Report on the Tolerance Analysis of PO Telescope for California Institute of Technology

To evaluate the tolerances provided by California Inst. of Tech. and to recommend optimized tolerances for PO telescope.

**RMS and P-V wavefront errors
(with 3 compensators)**

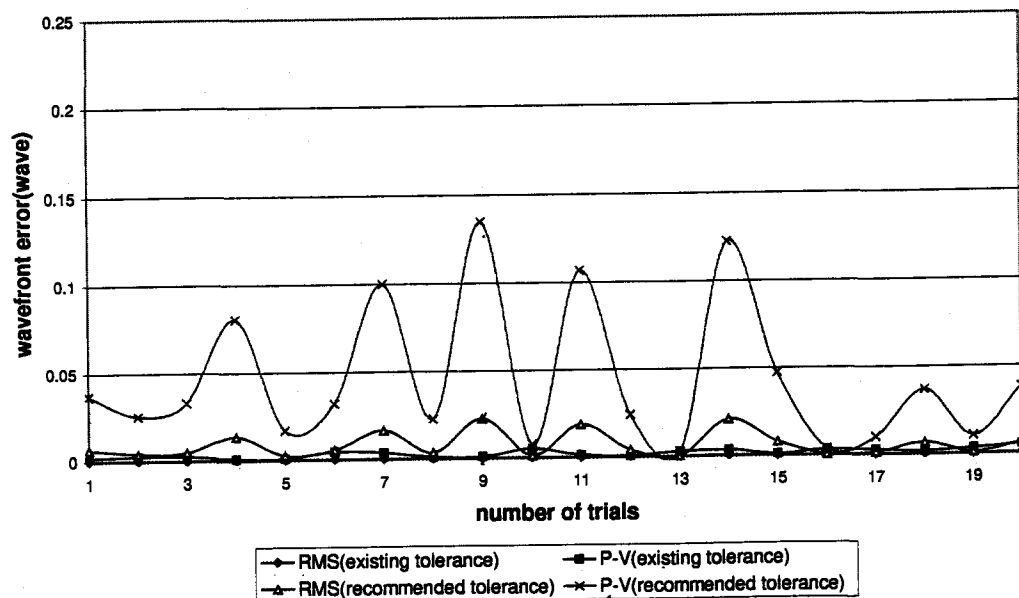
The following figure presents the RMS and P-V wavefront error for both existing tolerances and recommended tolerances with 20 Monte Carlo trials.

As the maximum P-V wavefront error is still far below 0.25 wave, it shows that some tolerances on optical elements can be further loosened if there are enough compensation ranges.

**RMS and P-V wavefront error for the recommended tolerance
 (only one compensator)**

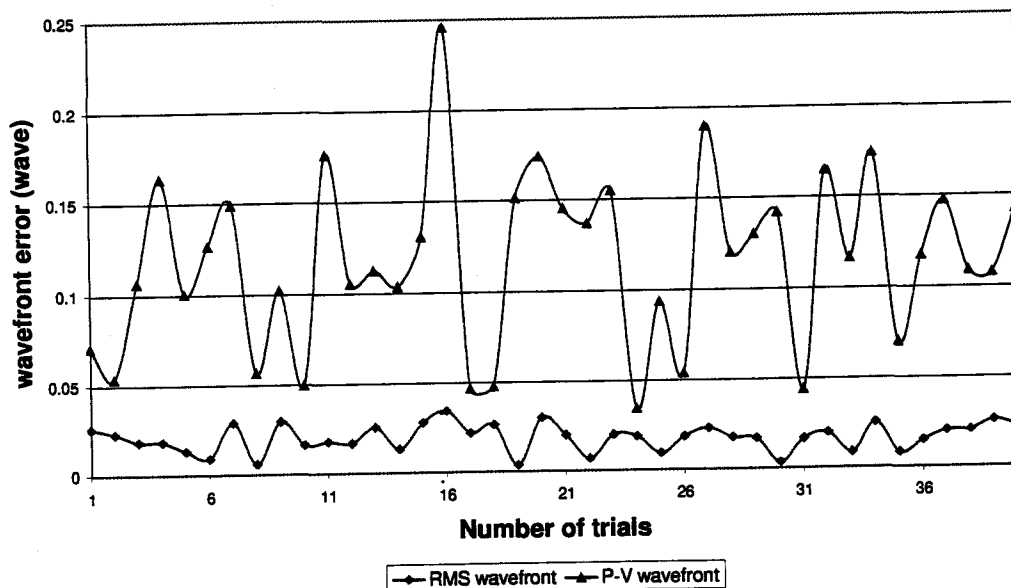
The maximum RMS wavefront error is 0.034532 wave and the maximum P-V wavefront error is 0.2462 wave. The following figure shows the relationship between the RMS wavefront and P-V wavefront for the 40 Monte Carlo runs.

These results have shown that the above-recommended tolerances would ensure the PO telescope has a P-V wavefront error less than 0.25 wave with about 99% confidence level even with one compensator, which is the spacing between the two mirrors.
